Private Fuel Storage, L.L.C.

COMMITMENT RESOLUTION LETTER #4
DOCKET NO. 72-22 / TAC NO. L22462
PRIVATE FUEL STORAGE FACILITY
PRIVATE FUEL STORAGE L.L.C.

RAI's 2-5 and 2-7 (first round), Seismic Program

Figure 1
PROPOSED LOCATIONS OF
CONE PENETROMETER TESTS
PRIVATE FUEL STORAGE FACILITY

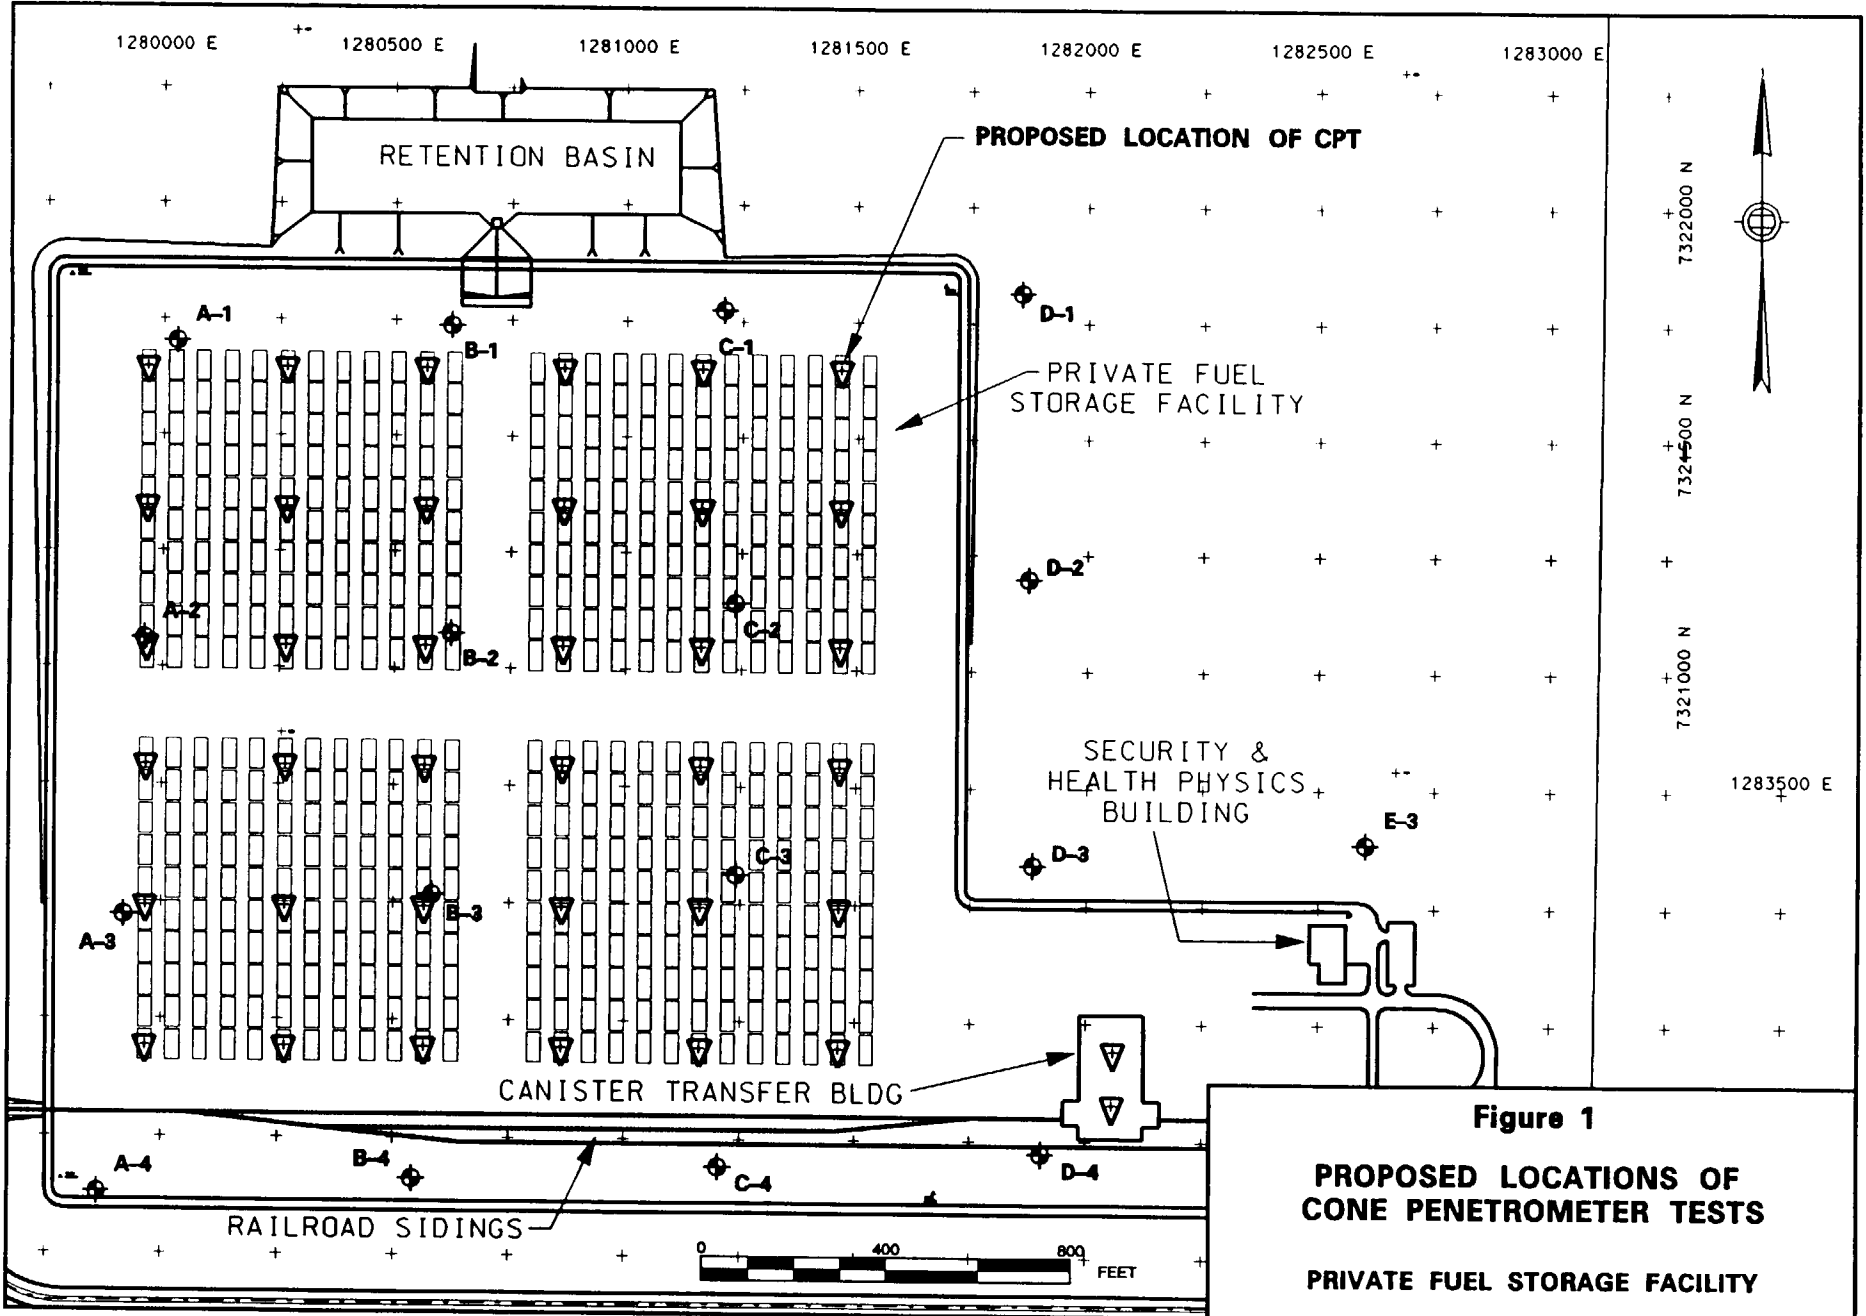
NRC Comment – The PFS field geotechnical investigation program is limited in the number of borings and tests provided and relies heavily on the Standard Penetration Test blow counts (N-values) to extrapolate results of laboratory tests to deeper soils within the profile. PFS should further justify that the subsurface conditions at the site are uniform. PFS should explain how the N-values were used in developing the SAR. In addition, PFS should provide profiles of shear strength and compressibility of the soils within the depth interval of 10 ft to ~25 ft. PFS should consider performing additional field tests to determine in situ shear strengths, such as field vane tests or cone penetrometer tests, to determine the extent and thickness of the lower blow count soils on site.

PFS Response – PFS will provide a report identifying how the N-values were used in developing the SAR. PFS will perform additional field work to develop profiles of strength and compressibility of the soils within the depth interval of 10 ft to ~25 ft. This program will include performing cone penetrometer tests (CPT) to develop continuous profiles of the strength of the soils in the upper layer (from the surface down to ~ 25 ft) within the pad emplacement area. Dilatometer tests will be performed using cone penetrometer technology to develop profiles of the compressibility of these in situ soils.

Phase 1 of this program will include performing 36 CPTs, located on a grid pattern of ~300 ft within the entire emplacement area. This pattern will provide nine CPTs in each of the four quadrants occupied by the cask storage pads shown in the attached Figure 1. Several of these CPTs will be located in close proximity to the locations of the borings that were drilled in the emplacement area to permit using the existing boring information in interpretation of the CPT data. The results of the Phase 1 CPTs will include continuous profiles of sleeve stress and tip resistance, which will be used to identify the extent and thickness of the lower blow count soils within the upper layer. These data will also be interpreted to provide profiles of soil stratigraphy, blow count, and strength.

In Phase 2, the cone penetrometer technology will be used to perform dilatometer tests (DMT) to develop profiles of the compressibility of the in situ soils at the locations identified in Phase 1 where the softer soils exist. These data are expected to provide sufficient information on the strength and compressibility of the in situ soils over the entire emplacement area.
